**BOARD OF ZONING APPEALS
CITY OF PRAIRIE VILLAGE
TUESDAY, JUNE 2, 2026
7700 MISSION ROAD
COUNCIL CHAMBERS
6:00 P.M.**

BZA2026-05 Variance for cumulative side setback
5009 W. 70th Street
Zoning: R-1B
Applicant: Scott McKenzie and Connie Link McKenzie

TO: Prairie Village Planning Commission
FROM: Chris Brewster, Multistudio, Planning Consultant
DATE: June 2, 2026, Board of Zoning Appeals Meeting

ENLARGED FLOOR PLAN 1
1/4" = 1'-0"

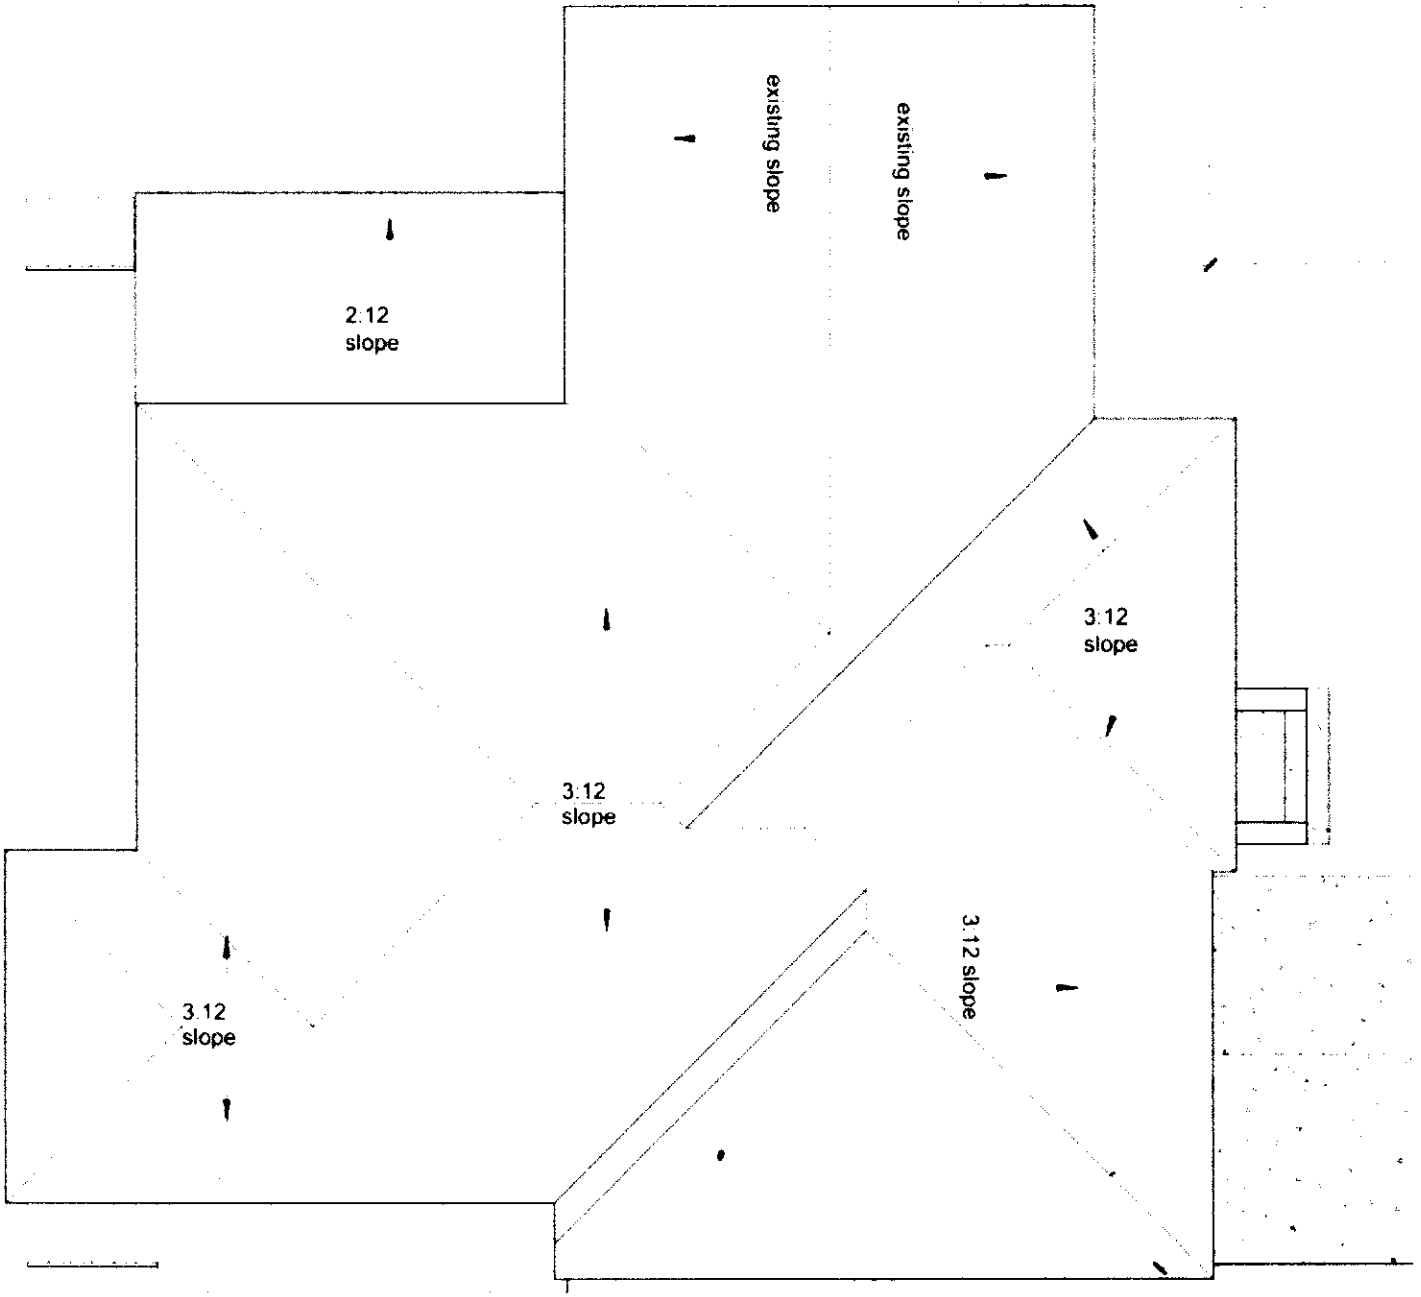
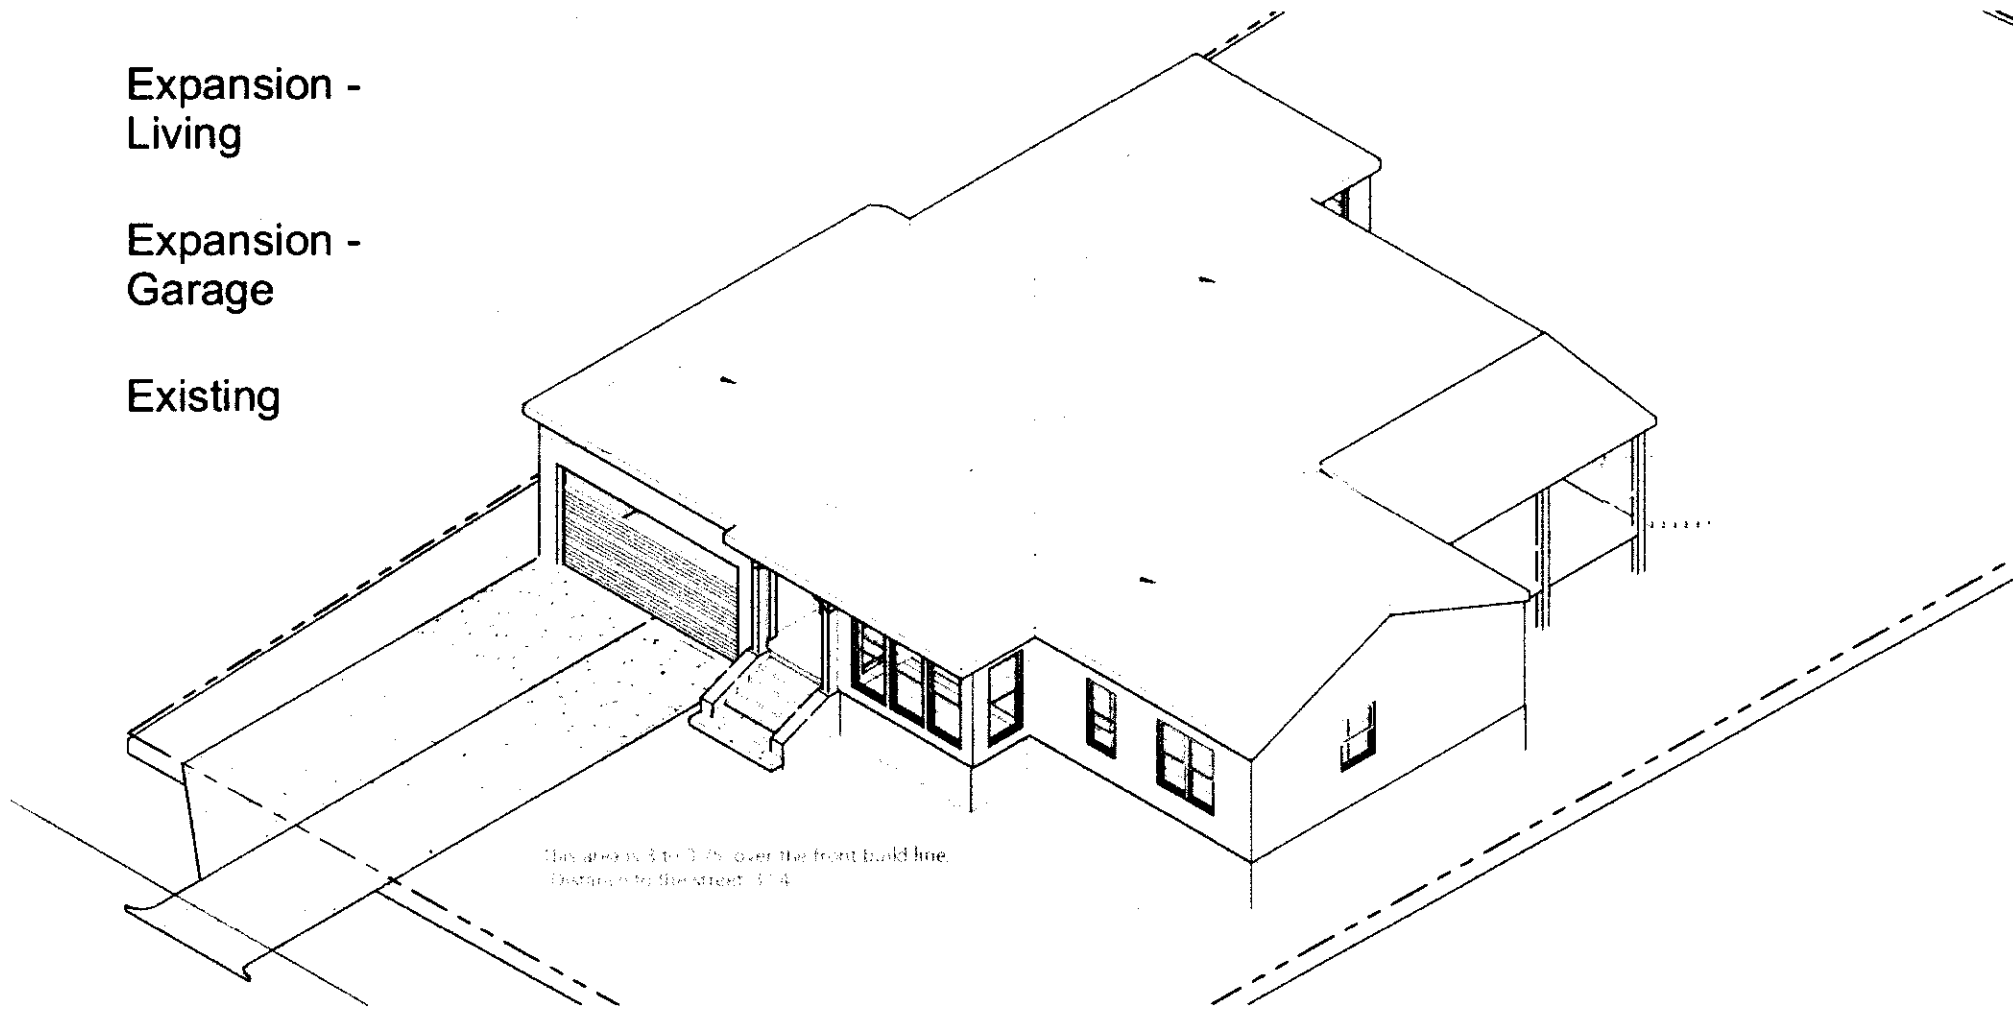
This corner is 1.95' over the cumulative side setback formula of 20% of the front build line distance.

This area is 3' x 3' over the front build line.
Distance to the street: 3' 4"
